**CAMP GEORGE WEST &
COLORADO TRANSPORTATION MANAGEMENT CENTER
Golden, CO**

Summary Observations

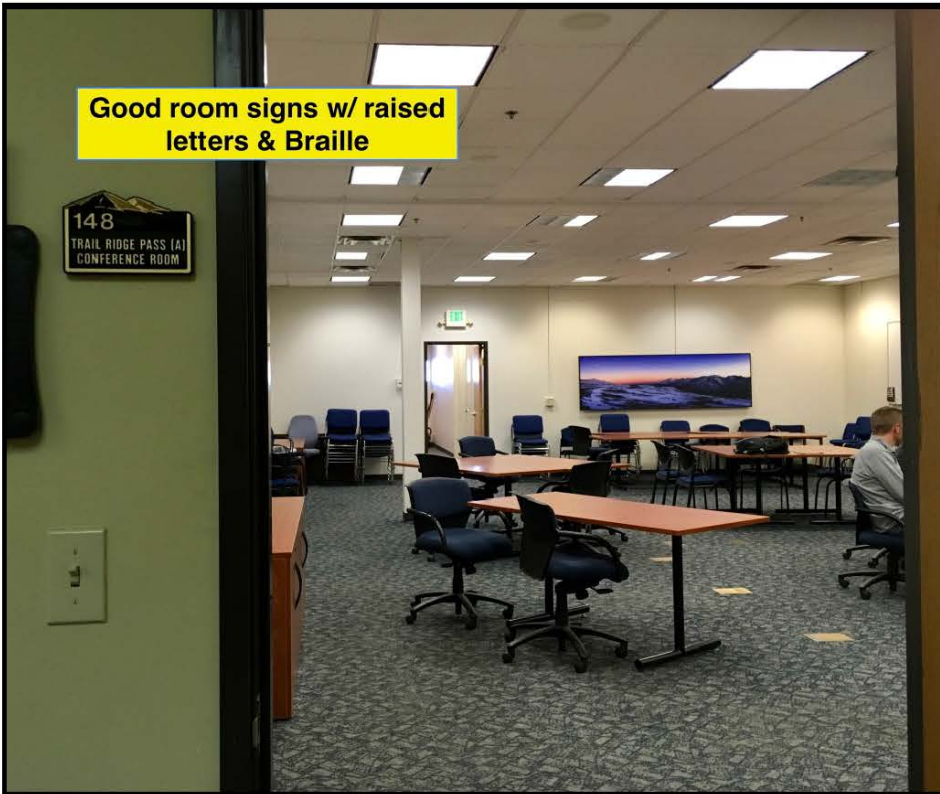
Grind down lip

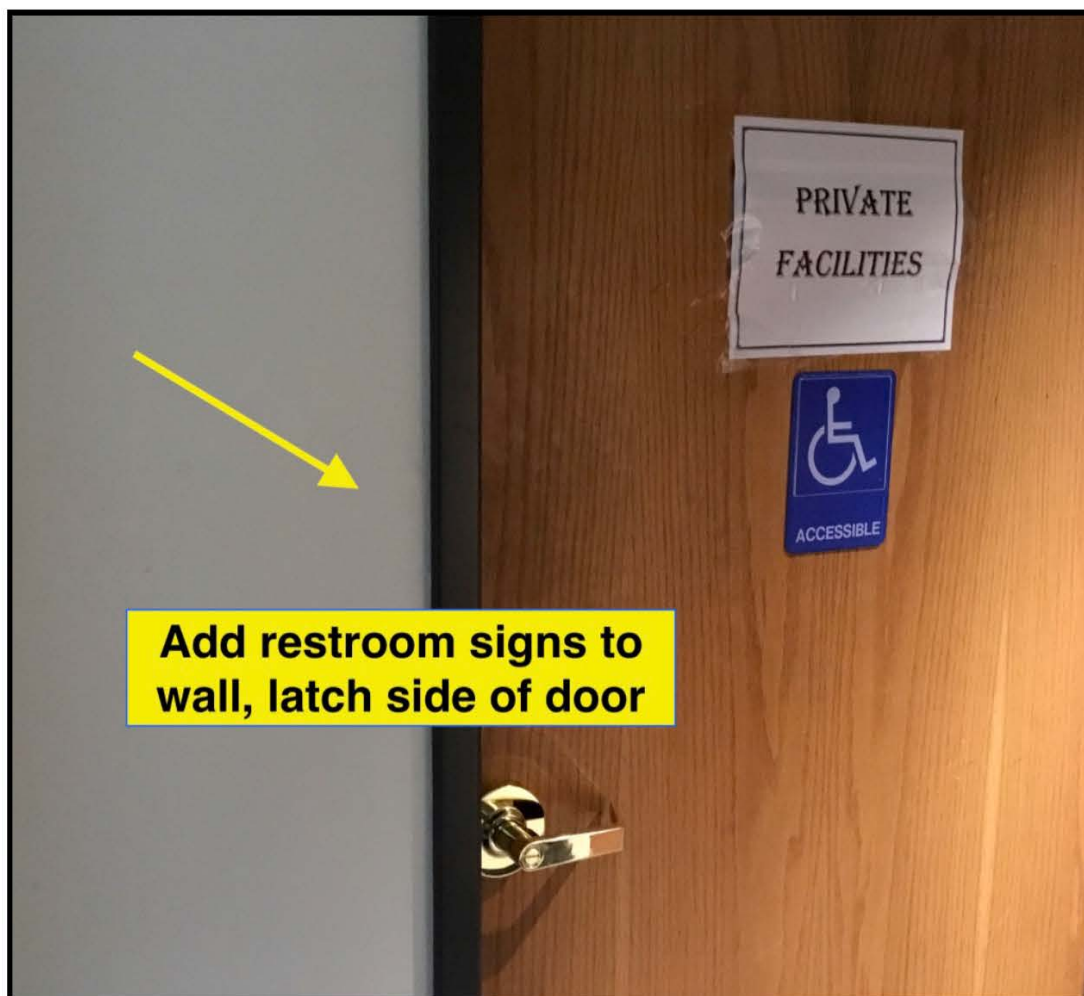
With 2 or more urinals, one should be lowered to 17"

Wrap pipes
